**CITY PLANNING COMMISSION**  
1231 "I" STREET, SUITE 200, SACRAMENTO, CA. 95814

B. Special Permit to construct a 100-seat, 13,963 square foot church with a church school on 0.76+ vacant acres in the Standard Single Family (R-1) zone.

**LOCATION:** 631 Eleanor Avenue

APPLC. NO. P89-344

SITE PLAN  
PHASE ONE

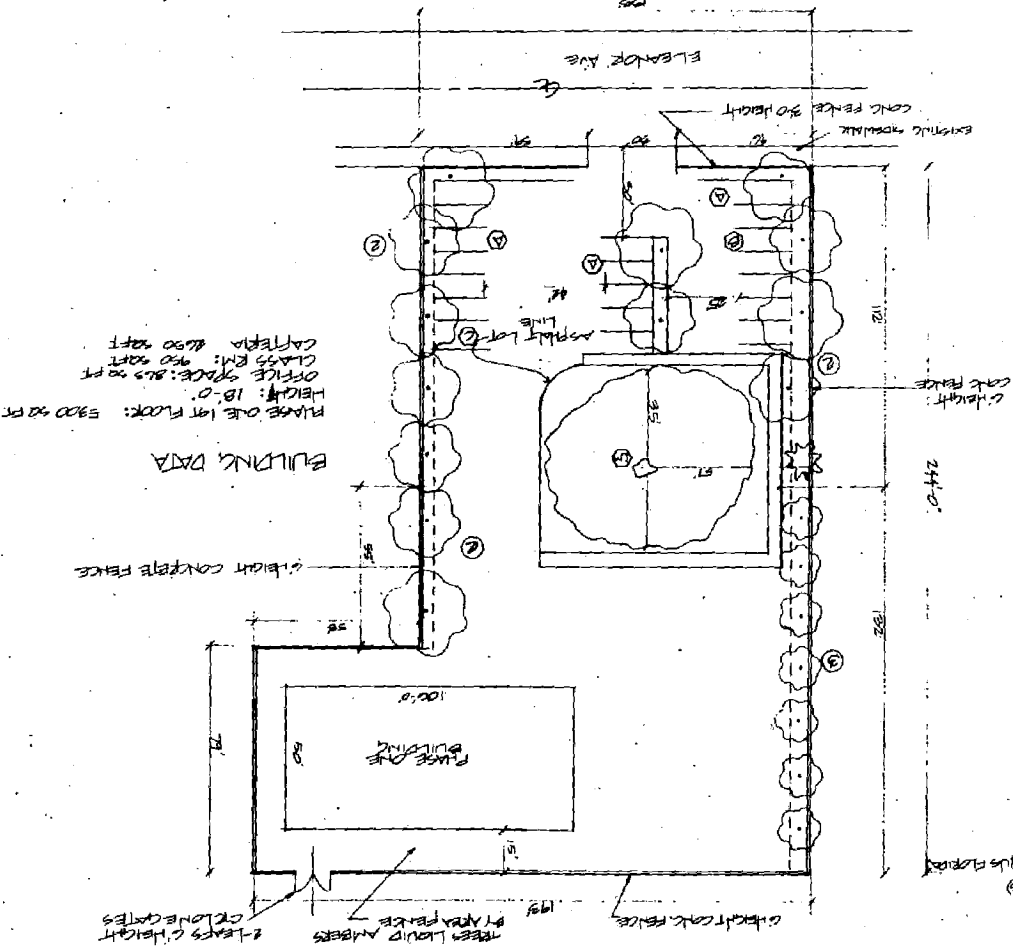
The submitted site plan (phase one) indicates a 5,300 square foot one-story school located at the northern portion of the site. One driveway entrance is located off of Eleanor Avenue and a cyclone gate (exit) is proposed at the rear of the subject site. The building is set back approximately 150 feet from the front property line, 5 feet from the interior side yard and 15 feet from the rear yard property line. A six foot high concrete fence is proposed around the east, west and north property lines; and a 3 foot high concrete fence is proposed along Eleanor Avenue.

A large heritage oak with a 63 foot limb-span exists on the subject site. This tree is located almost exactly in the center of the property. All structures, landscaping and surfaced areas must, therefore, be located outside of the tree's drip line. Staff recommends that a temporary 6 foot high chainlink fence be placed around the drip line of the tree to prevent soil compaction. The applicant is proposing to construct a 4 foot wide asphalt walkway along the north, west and south portions of the tree for pedestrian access to the church.

No trash enclosures or signage is indicated on the submitted site plans. Staff recommends that a trash enclosure be provided on the site and comply with the City's Trash Enclosure Ordinance. Any signage proposed on the site shall be reviewed and approved by the Planning Director prior to issuance of sign permits.

The layout of the parking lot indicates a total of nineteen parking spaces (13 standard parking spaces, 5 compact spaces, 1 handicap space). The Zoning Ordinance requires one space per every 6 church seats. The 19 parking spaces proposed on the subject site will be adequate. The 50 percent shading requirement in the parking lot shall be met. One driveway entrance off of Eleanor Avenue is indicated on the site plan.

1. The applicant shall submit a landscape and irrigation plan for staff's review and approval prior to issuance of building permits.

2. A trash enclosure shall be provided on the subject site and shall comply with the City's Trash Enclosure Ordinance.
3. Any signage proposed on the subject site shall be reviewed and approved by the Planning Director prior to issuance of sign permits.
4. The 50 percent shading requirement shall be met in the designated parking lot.
5. The applicant shall submit revised elevations and a site plan with revisions for review and approval by the Design Review Coordinator.

9. A tree preservation plan shall be submitted for the review and approval of the City Arborist. This plan shall include the following measures to ensure the health and vitality of the tree:

NORTH ELEVATION SCALE 1/8"=1'-0"

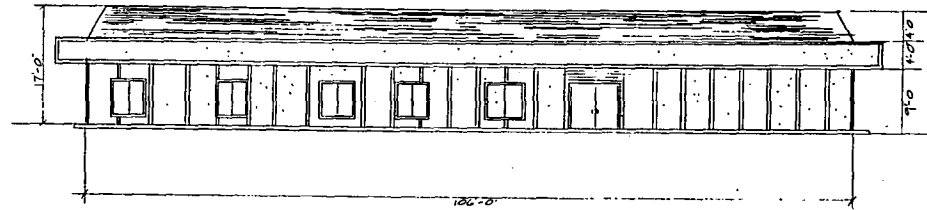
The proposed building design was reviewed by the City's Design Review Coordinator. The Design Review Coordinator had some concerns with the buildings overall lack of architectural interest.

Staff met with the applicant and discussed revisions to the building design with particular focus on the arrangement of windows and doors and roof form. The applicant has agreed to modify his plans with these concerns in mind, and will also seek to create a focal point of architectural interest possibly in the form of a covered central entry. Staff recommends that the applicant resubmit revised elevations and a site plan reflecting revisions for the Design Review Coordinator's review and approval prior to issuance of building permits.

SITE PLAN SECOND PHASE

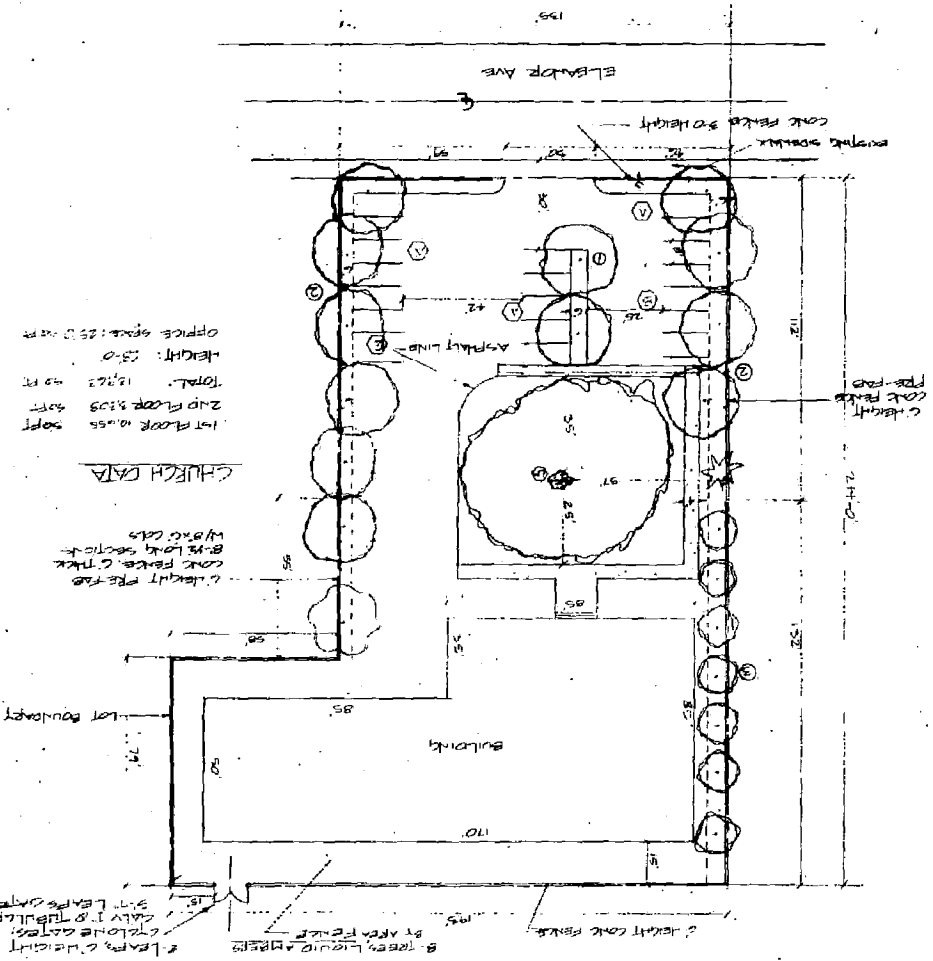
The school and church will be constructed in two phases. Phase one will be the school use and phase two will be the two-story church and additional school space. The second level will contain a study room and recording facility rooms. The submitted site plan identifying the second phase

indicates a 15 foot rear yard setback and an 11 foot side yard setback (west).
